## Executive Director's Recommendation

Commission Meeting: July 9, 2015

<b>PROJECT</b> <b>Intelligence Community Campus – Bethesda, Master Site Design</b> Intelligence Community Campus - Bethesda 4600 Sangamore Road Bethesda, MD	<b>NCPC FILE NUMBER</b> 7326
<b>SUBMITTED BY</b> United States Department of Defense, Army Corps of Engineers on behalf of the Defense Intelligence Agency	<b>NCPC MAP FILE NUMBER</b> 3101.10(38.00)44092
<b>REVIEW AUTHORITY</b> Federal Project in the Environs Per 40 U.S.C. § 8722(b)(1)	<b>APPLICANT'S REQUEST</b> Preliminary approval of site development plans
	<b>PROPOSED ACTION</b> Approve with comments
	<b>ACTION ITEM TYPE</b> Staff Presentation

Figure 20: Landscape Zonal Plan

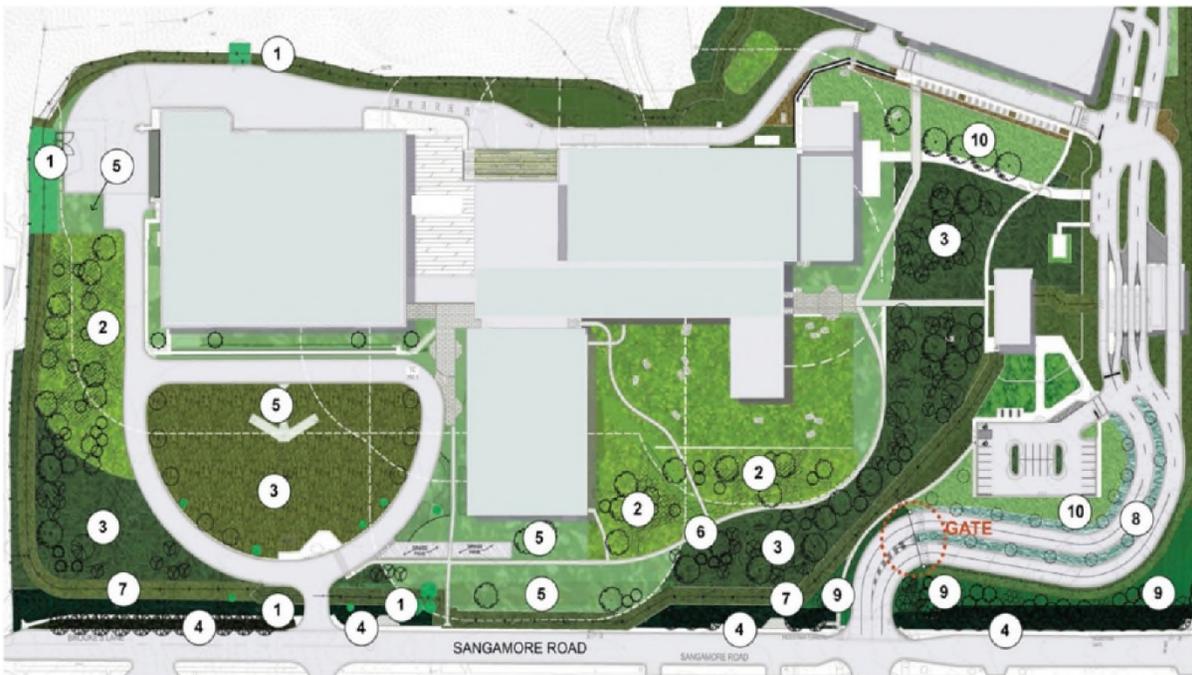
A clear area of ten feet on either side of the fence line is required throughout the campus. In areas where sun is plentiful, turf is planted for approximately 38,000 square feet. In areas of heavy tree cover such as along the western and northern border, river rock/round stone (2” maximum) for approximately 6,000 square feet is proposed for the ground surface to reduce maintenance requirements. The applicant states that this could also be done with mulch bedding materials.

**Staff recommends that the applicant eliminate river rock/round stone along the required ten feet clear area on either side of the fence, specifically along the western border. Consider alternative treatments for this sensitive sloped area such as turf or native ground cover and consider associated maintenance given the security constraints.** NCPC staff concurs with the concern raised by the Montgomery County Planning Board to limit the potential for off-site migration of gravel down the slope and into sensitive areas such as the Potomac Palisades which could smother and kill native plant understory. NCPC staff does not recommend using gravel or mulch bedding materials in this area, since this will negatively impact the surrounding landscape, instead staff recommends considering native ground cover or turf.
